**Re: Highlands Hotel (Spring Hill Suites)
Central Ave & Mulberry St., 87106
30-Day Temporary Certificate of Occupancy
Transportation Development Final Inspection**
Engineer's/Architect's Stamp dated 4-23-20 (AA) (K15D034B)
Certification dated 7-23-20

ADMINISTRATIVE AMENDMENT

SPRINGHILL SUITES - ALBUQUERQUE
CENTRAL AVE. & MULBERRY ST.
ALBUQUERQUE, NM 87106

SITE PLAN

PRELIMINARY SITE PLAN

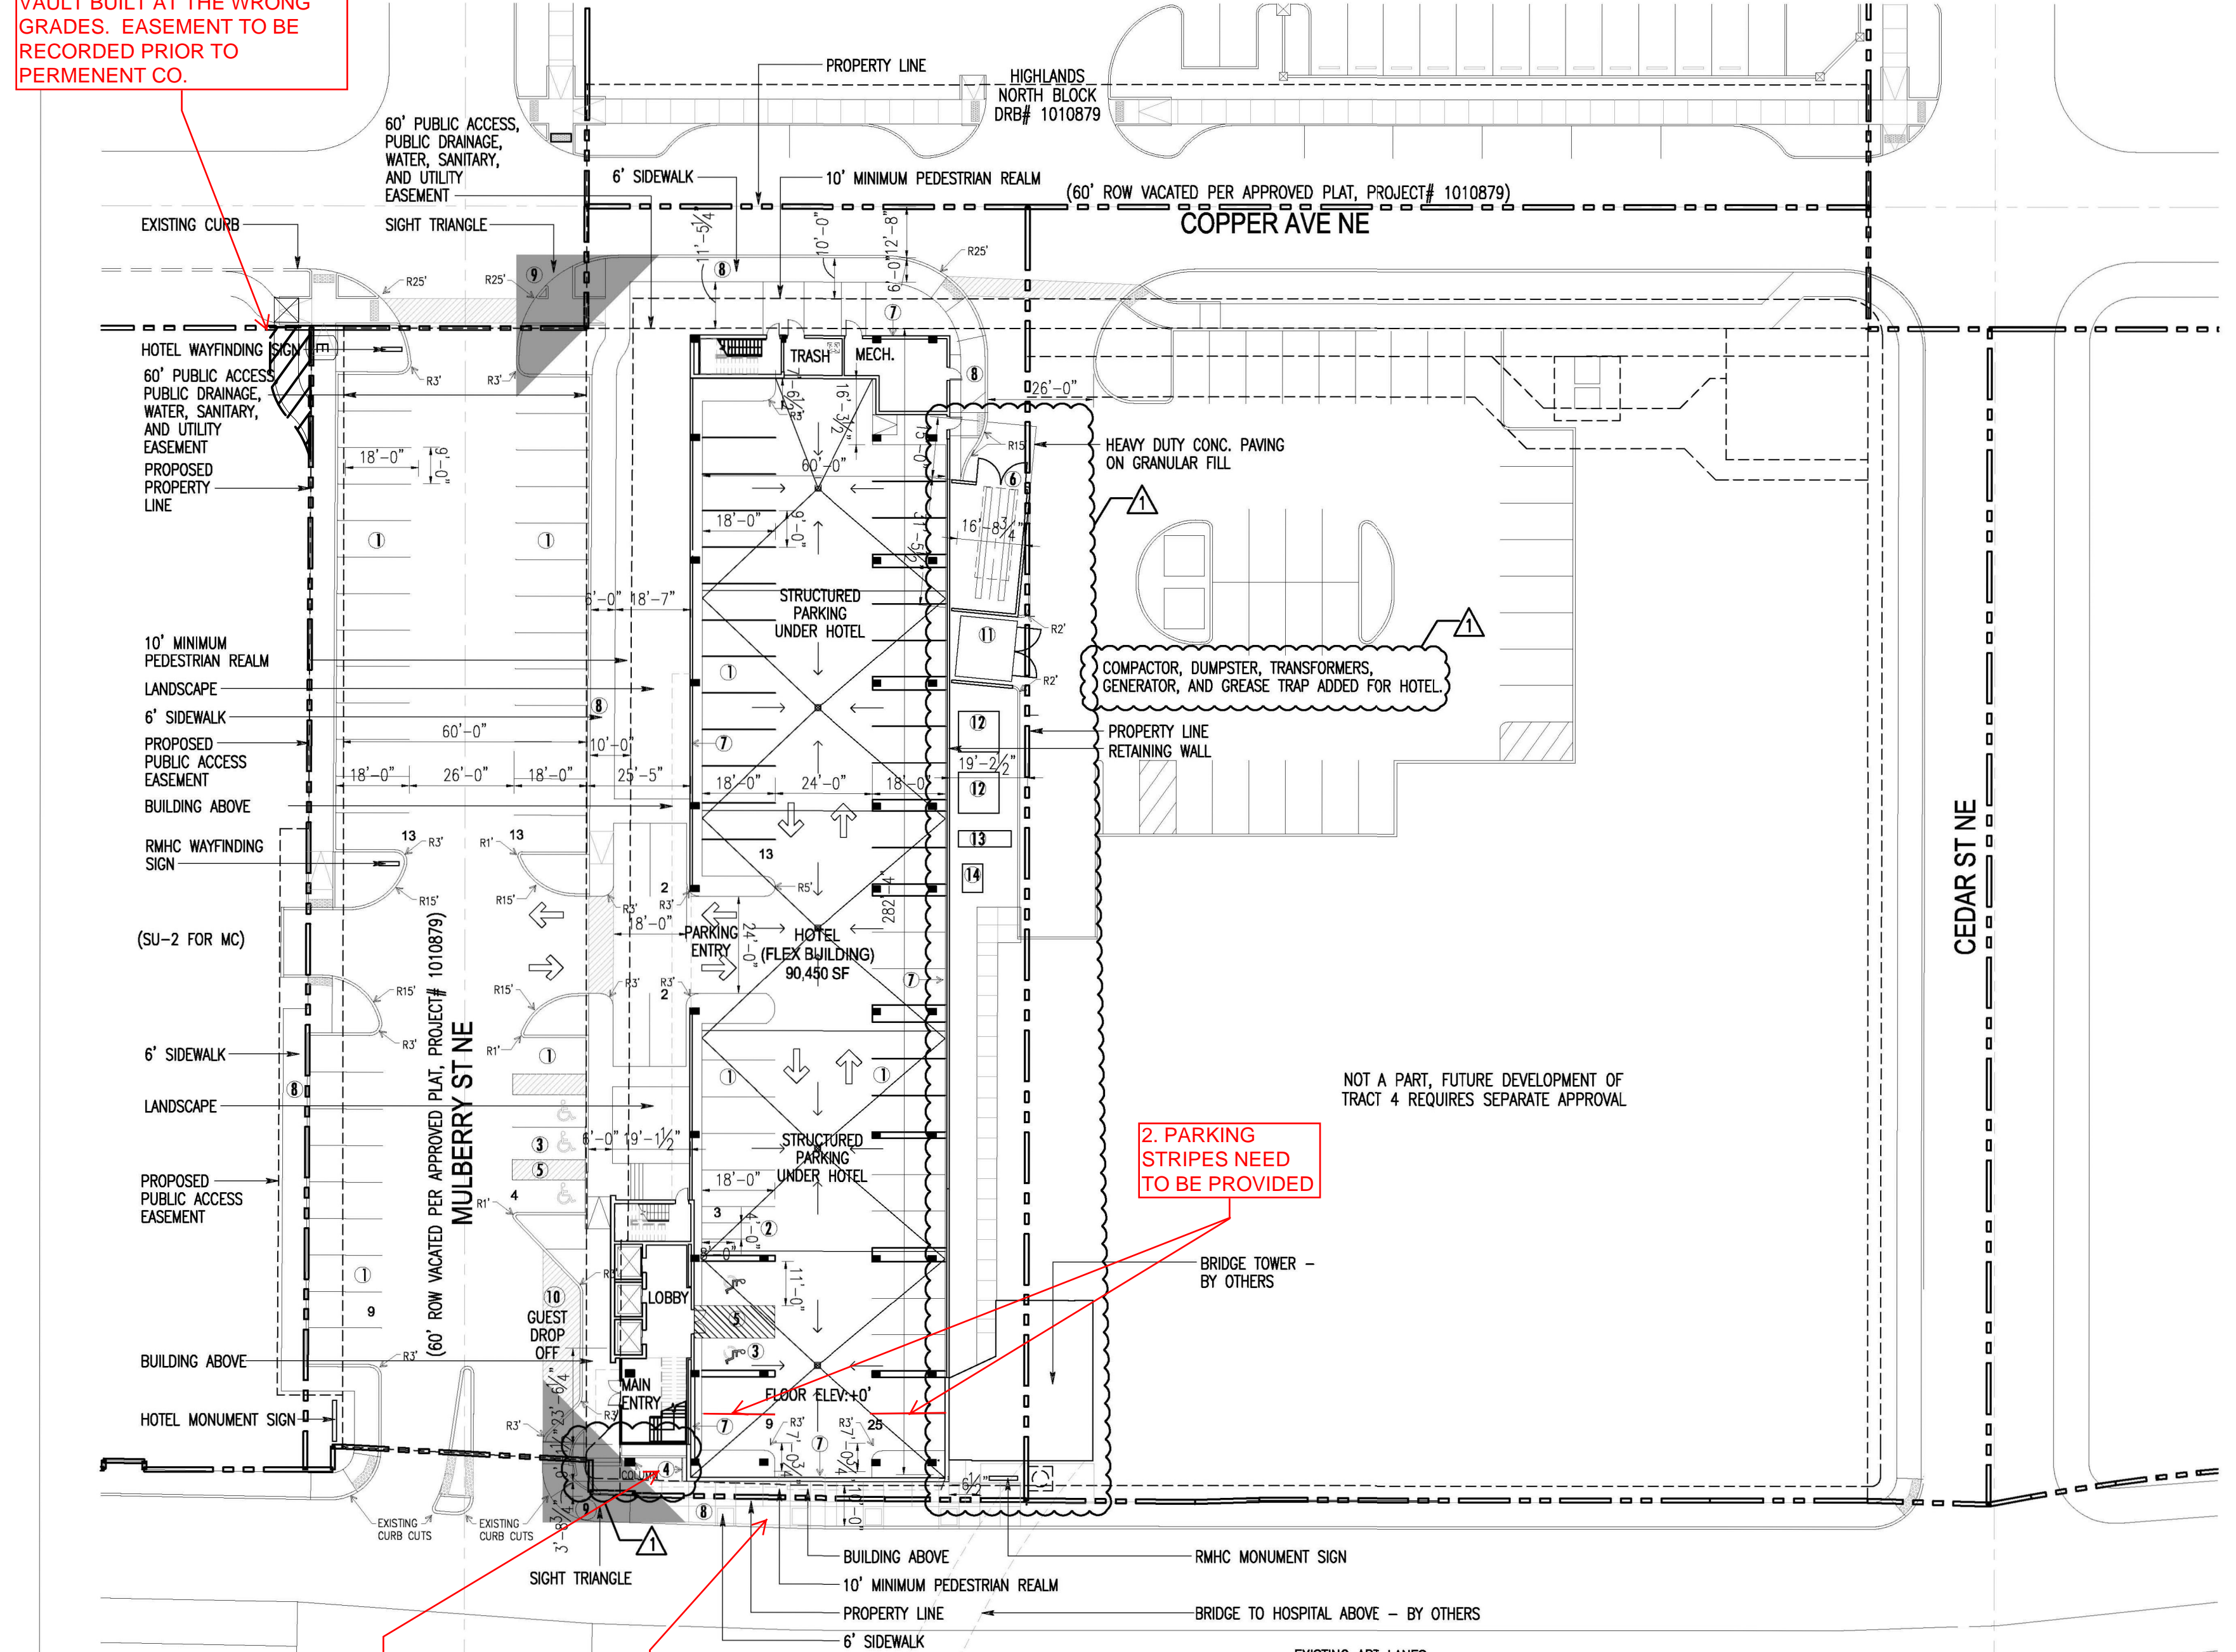
- Please attach easement for sidewalk relocation.
- Please add bike rack
- Please remove construction debris and equipment from parking under hotel.
- Please fill gaps on brick pavers.
- Please correct traffic signal box to be flush with brick pavers.

4. REALIGNED SIDEWALK TO ACCOMMODATE EXISTING PNM VAULT BUILT AT THE WRONG GRADES. EASEMENT TO BE RECORDED PRIOR TO PERMENENT CO.

2. PARKING STRIPES NEED TO BE PROVIDED

3. BIKE RACK WILL BE INSTALLED ONCE BRICK PAVERS ARE COMPLETE

1. BRICK PAVERS ARE CURRENTLY BEING CONSTRUCTED UNDER COA WORK ORDER # 764783 AND WILL BE COMPLETED PRIOR TO PERMENENT CO
